REQUEST FOR INFORMATION	DATE: April 20, 2016	NO.: RFI-045
--------------------------------	-----------------------------	---------------------

Project Name: Webster University Interdisciplinary Science Building

Subject: Steel detailing questions

S0106

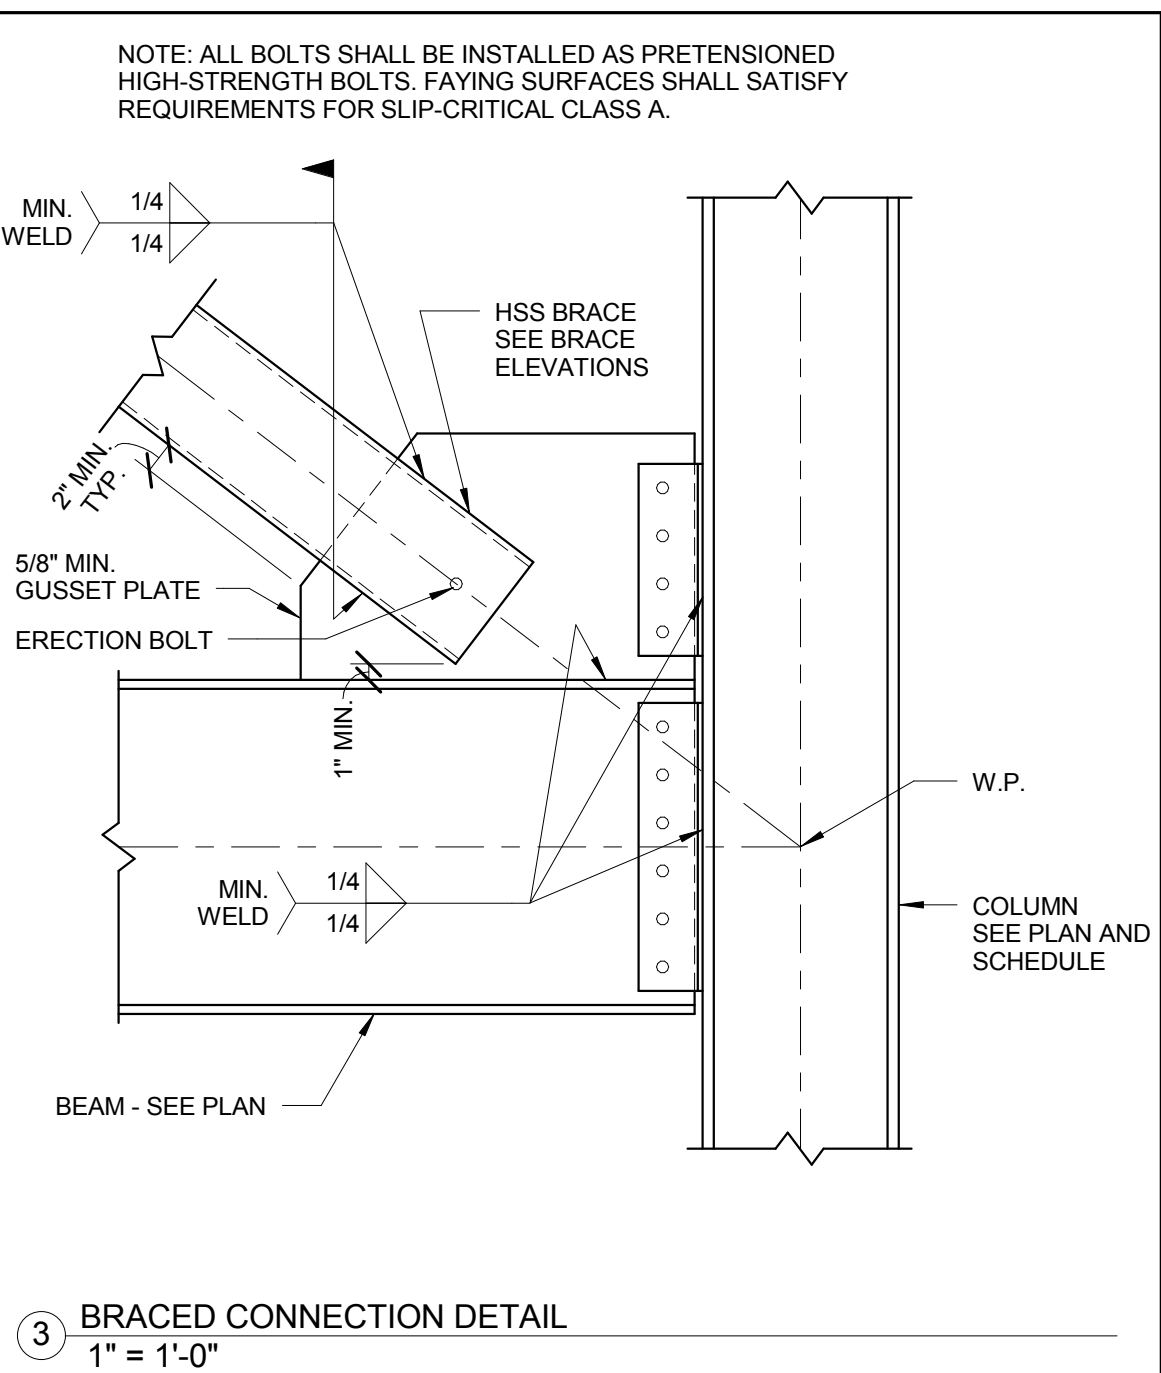
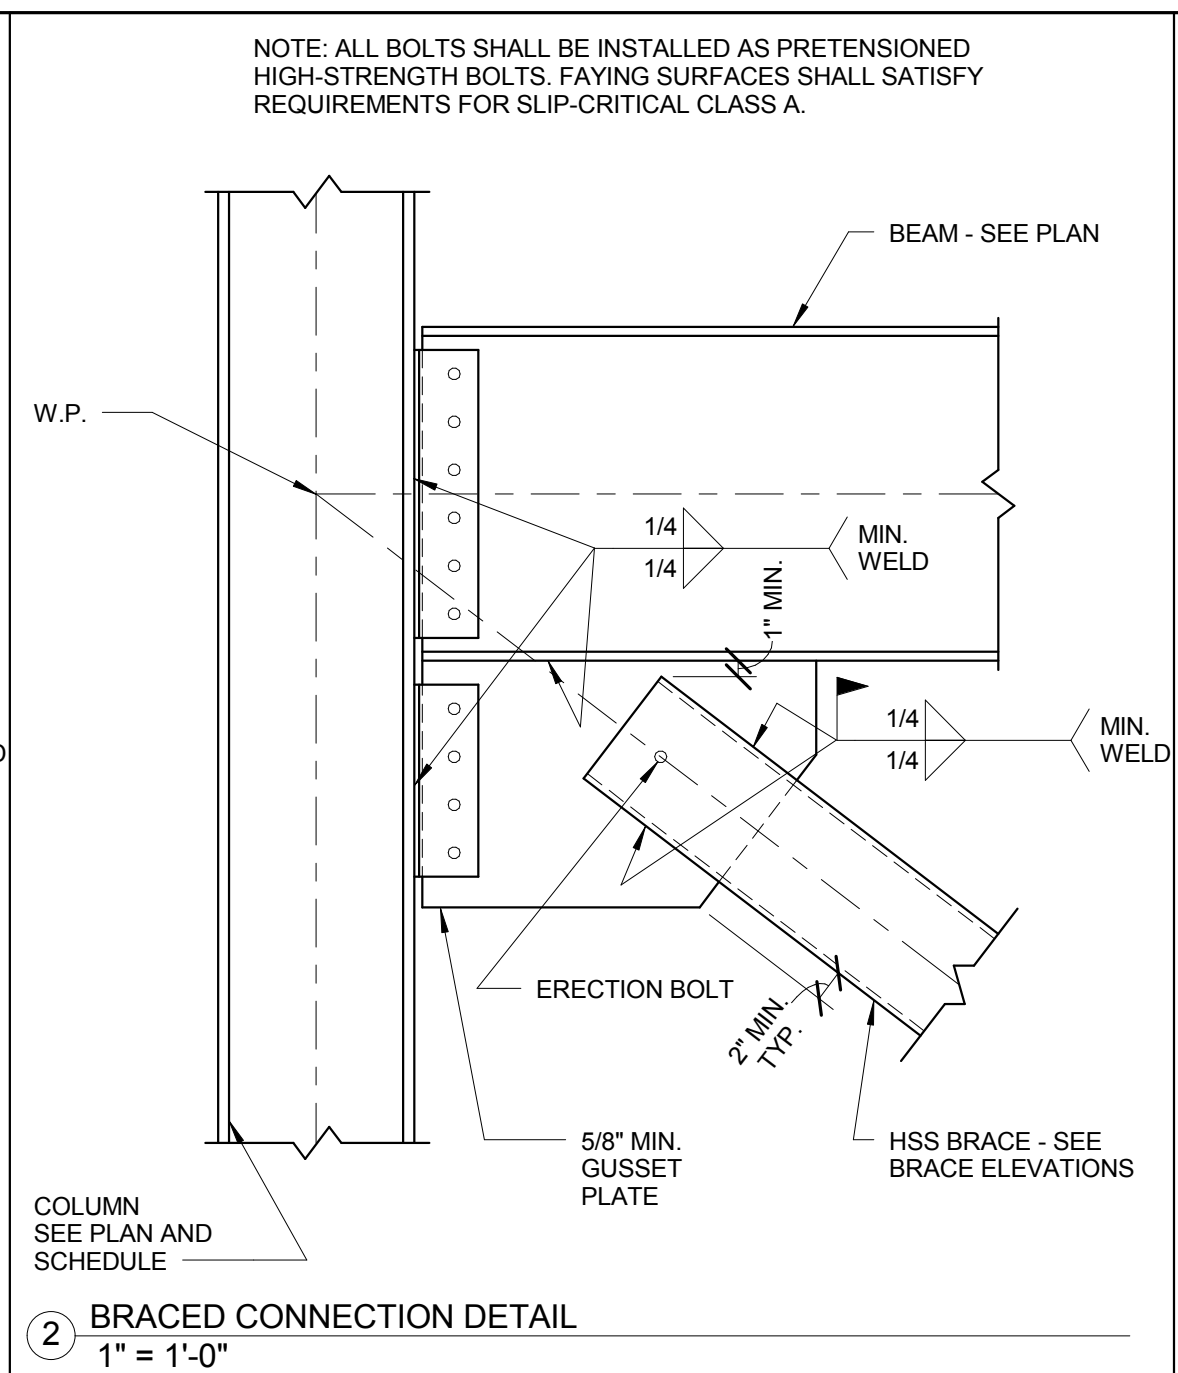
9. The tube size is 6x6x5/8, but it shown
6x4x3/8 on S0500, please clarify.

ALL SCREEN WALL POST COLUMNS SHALL BE HSS6X6X5/8"
